**CITY OF WINTER PARK  
PLANNING AND ZONING BOARD**

**Staff Report  
June 6, 2017**

REQUEST OF DOROUGH BROTHERS PROPERTIES, LLC FOR: SUBDIVISION OR LOT SPLIT APPROVAL TO DIVIDE THE PROPERTY AT 331 S. LAKEMONT AVENUE, ZONED R-1A, INTO TWO SINGLE FAMILY BUILDING LOTS, FRONTING ON GRINNELL TERRACE. EACH PROPOSED LOT WILL MEET OR EXCEED THE MINIMUM LOT SIZE REQUIREMENTS OF THE R-1A ZONING OF 75 FEET OF LOT WIDTH AND 8,500 SQUARE FEET OF LOT AREA AND NO VARIANCES ARE REQUESTED.

331 S Lakemont Ave  
Lot Split Request

CONCEPTUAL LOT SPLIT SITE PLAN - LOT 1  
SCALE: 1"=10'

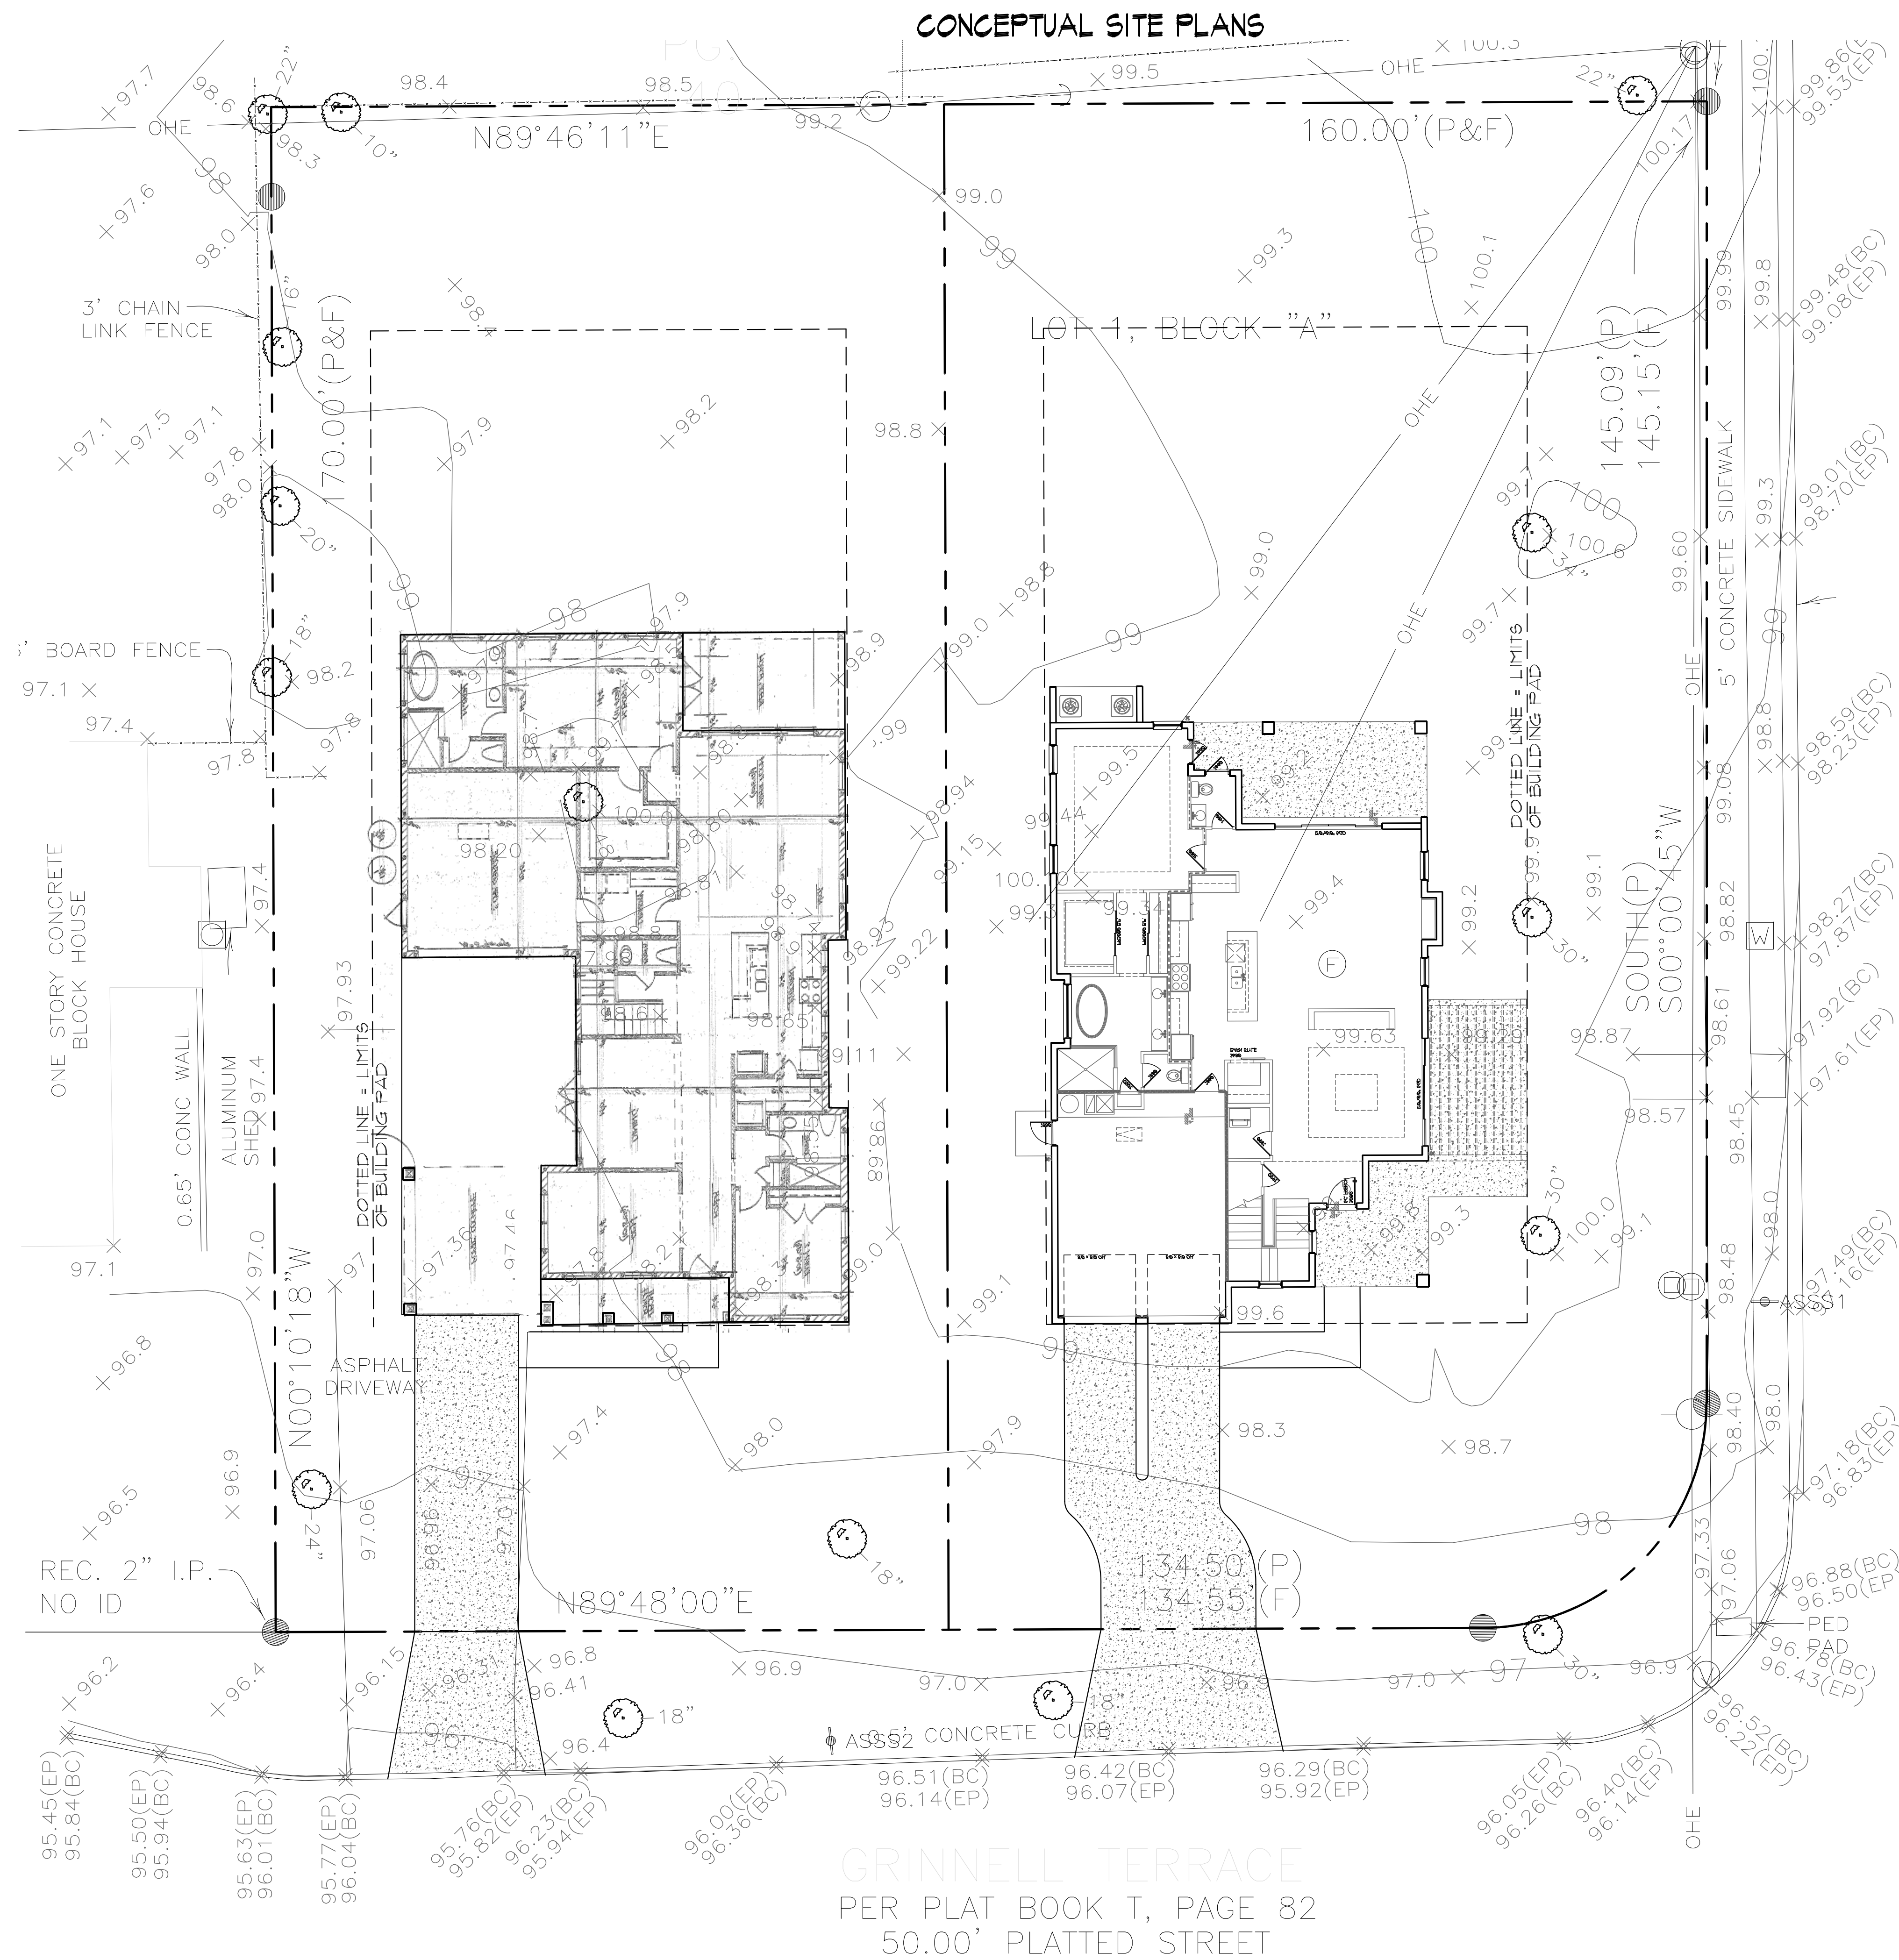
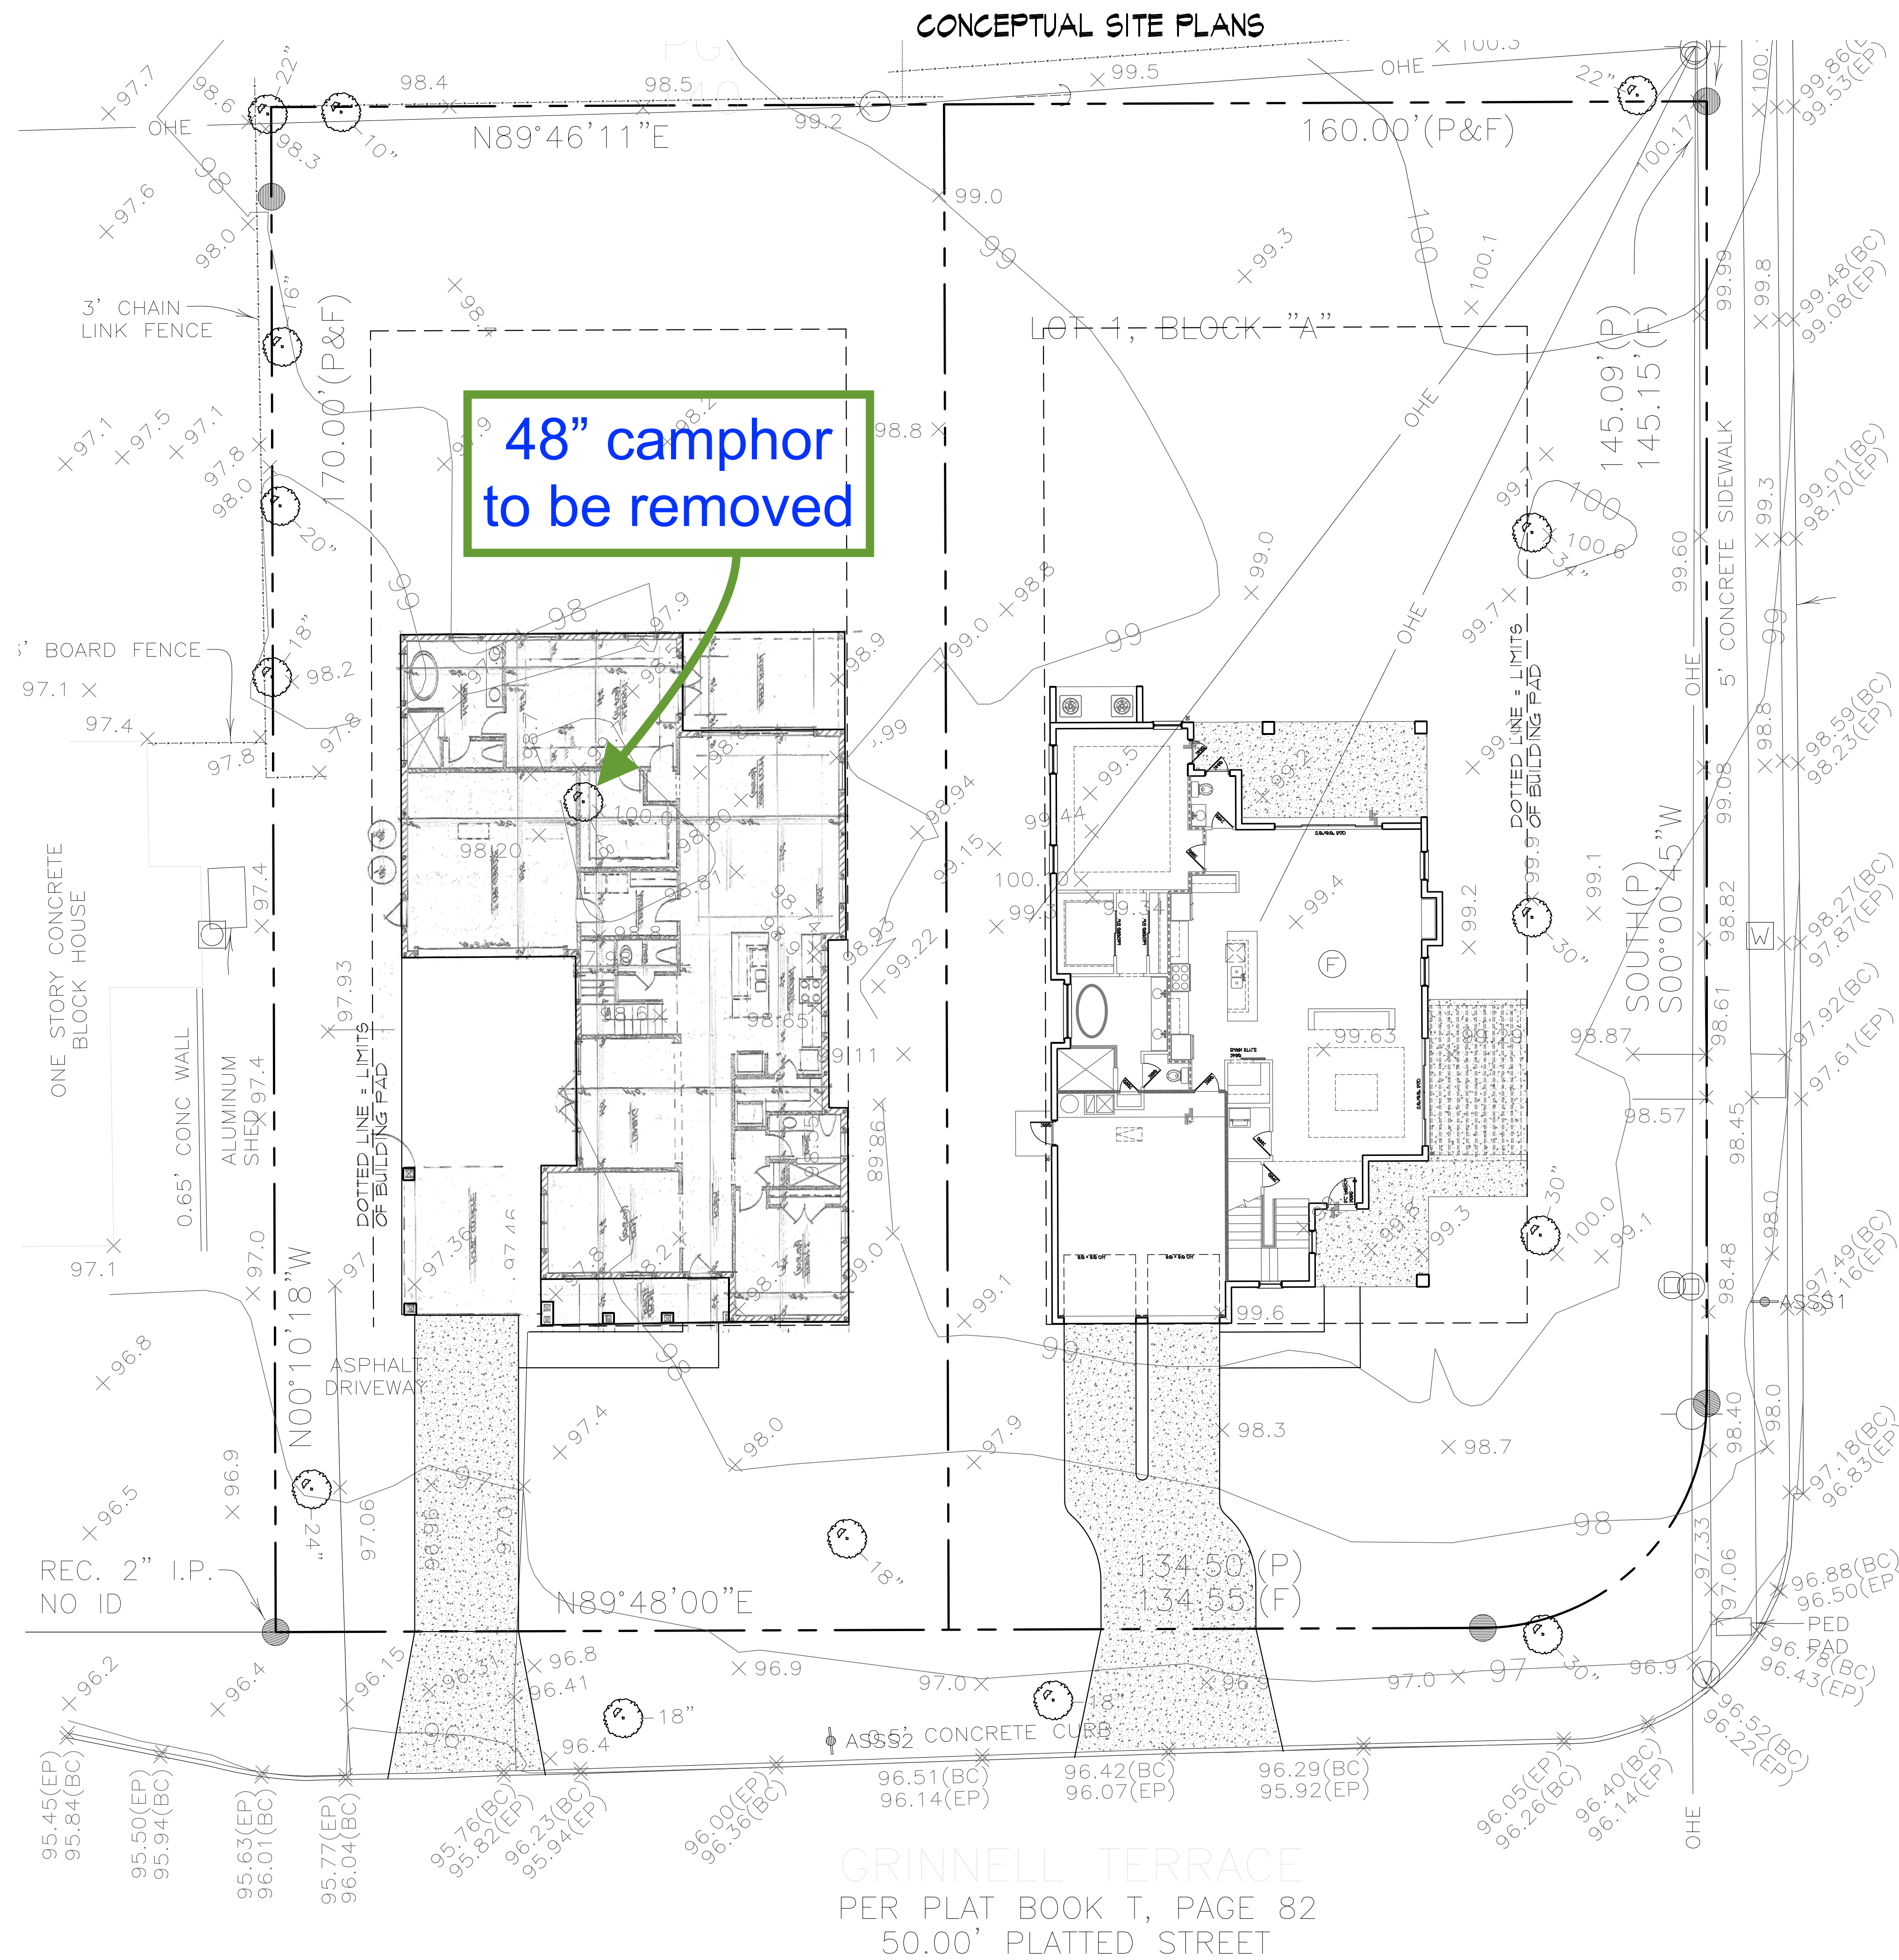
**DEVELOPMENT PLANS:** The applicant has provided a generalized front elevation for the type of homes that they plan to build, and general site plans for the layout of the proposed new homes. Based on the proposed site plans, the application will only be removing one 48" camphor tree in the western lot due to this request. Also, staff is recommending that a condition be placed that these homes be of varying architecture as the applicant has presented. The applicants will comply with the normal single-family development standards, setbacks, etc.

1. That the proposed homes be of varying architecture.
2. That the applicant preserves that existing trees, with the exception of the 48" camphor located within the western home's footprint.

- There are two trees on the site that are in poor condition both along the east side along S. Lakemont Ave.
- There are eleven trees throughout the property that are in good condition and need to be considered when designing the footprint.
- A camphor tree on site is quite large and is healthy; although not protected under the Tree Preservation Ordinance.
- Staff will wait on proposed building plans to determine approval of tree removal requested.
